MIL-PRF-19500/743C
w/AMENDMENT 3
25 February 2026
SUPERSEDING
MIL-PRF-19500/743C
w/AMENDMENT 2
12 July 2021

PERFORMANCE SPECIFICATION SHEET

TRANSISTOR, FIELD EFFECT, N-CHANNEL, RADIATION HARDENED
SILICON, TYPES 2N7503,
JANTXVR, F, G AND H AND JANSR, F, G AND H

FIGURE 1. Physical dimensions for SMD-0.2, 2N7503U8 and 2N7503U8C.

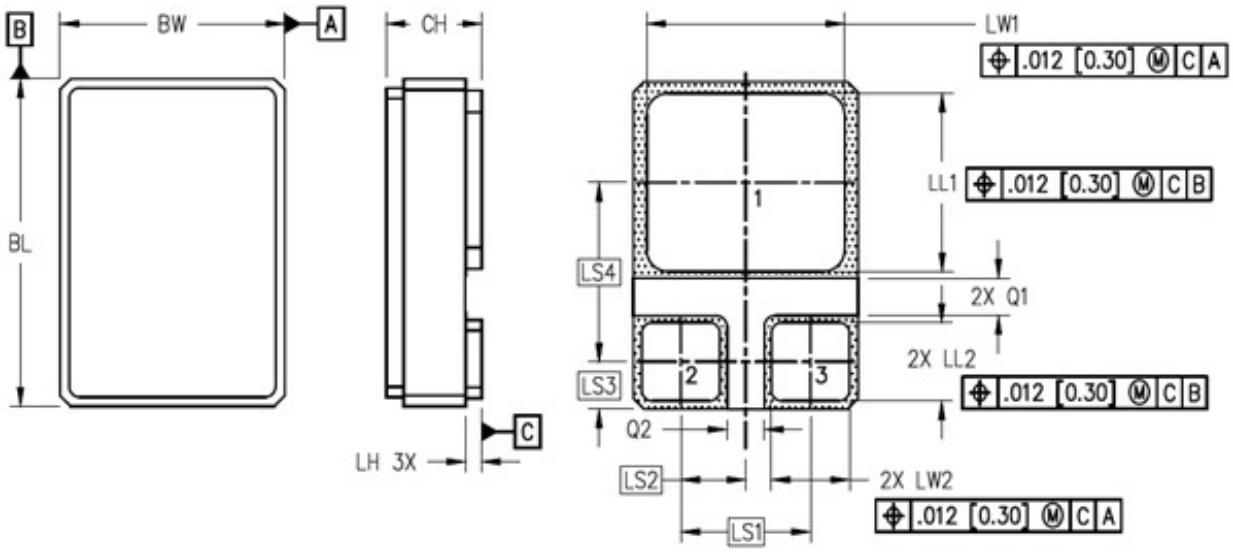
* NOTES:
1. Dimensions are in inches.
2. Millimeters are given for general information only.
3. The lid shall be electrically isolated from the drain, gate and source.

* FIGURE 2. Dimensions and configuration (Similar to SMD-0.2), with ceramic lid (U8CE).

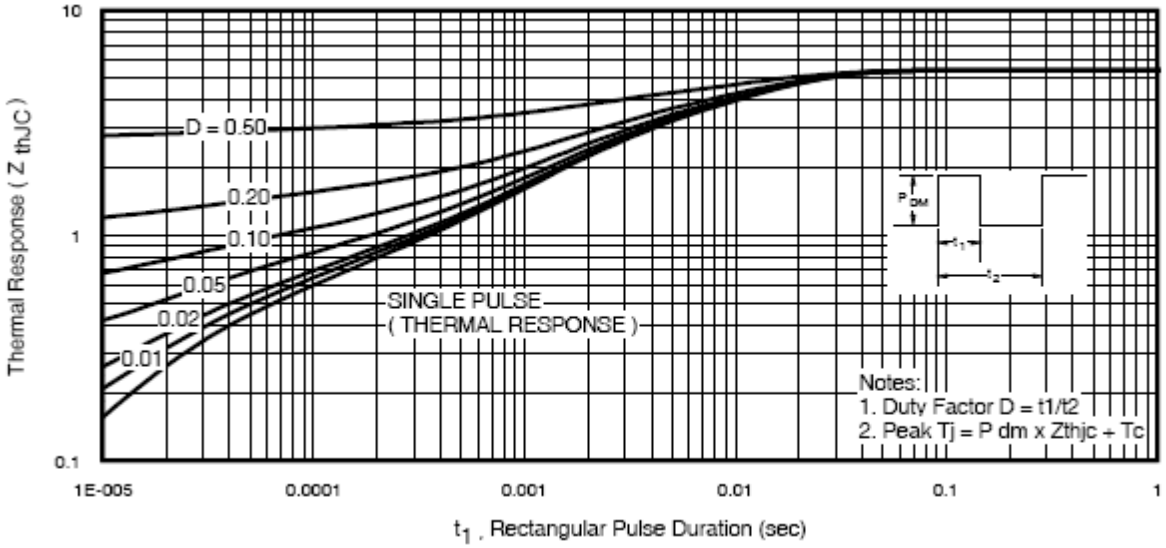
Symbol	Dimensions			
	Inches		Millimeters	
	Min	Max	Min	Max
BL	.300	.310	7.62	7.87
BW	.205	.215	5.21	5.46
CH		.097		2.46
LH	.010	.020	0.25	0.51
LW1	.180	.190	4.57	4.83
LW2	.068	.078	1.73	1.98
LL1	.161	.171	4.09	4.34
LL2	.068	.078	1.73	1.98
LS1	.121 BSC		3.07 BSC	
LS2	.061 BSC		1.55 BSC	
LS3	.044 BSC		1.12 BSC	
LS4	.167 BSC		4.24 BSC	
Q1	.030		0.76	
Q2	.030		0.76	
TERM 1	Drain			
TERM 2	Gate			
TERM 3	Source

NOTES:
1. Dimensions are in inches.
2. Millimeters are given for general information only.
3. Lid is isolated.

* FIGURE 4. Maximum drain current versus case temperature graphs.

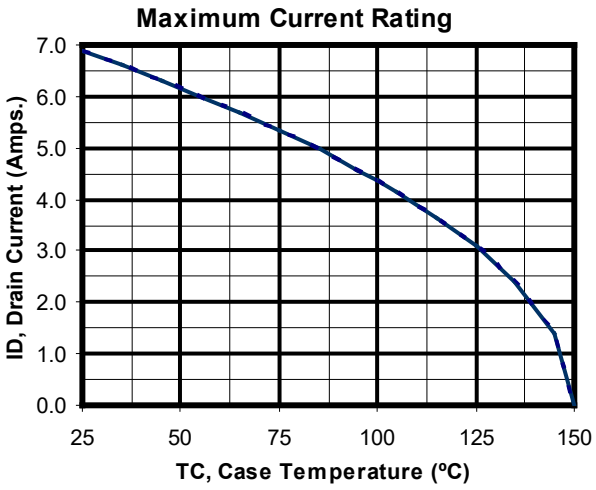
2N7503U8, 2N7503U8CE **2N7503U8C,**

* FIGURE 6. Typical SEE safe operating area graph.

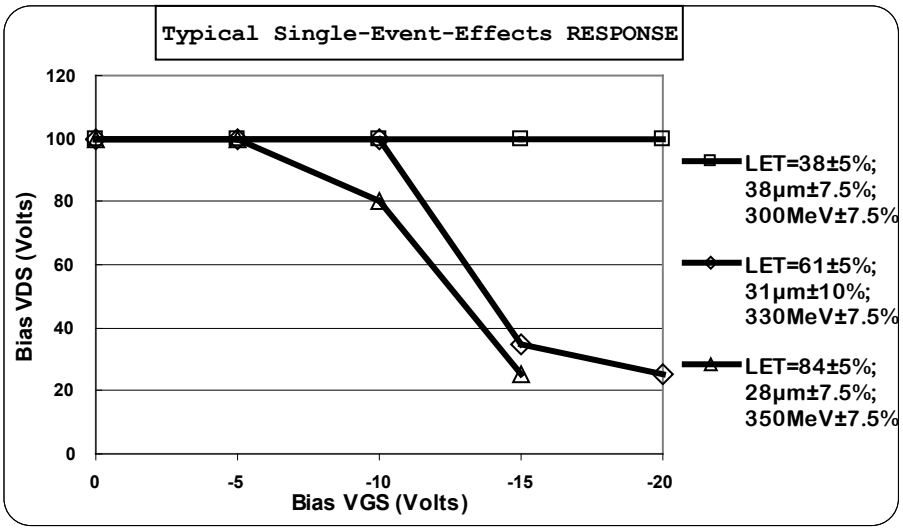
2N7503U8, 2N7503U8C, U8CE
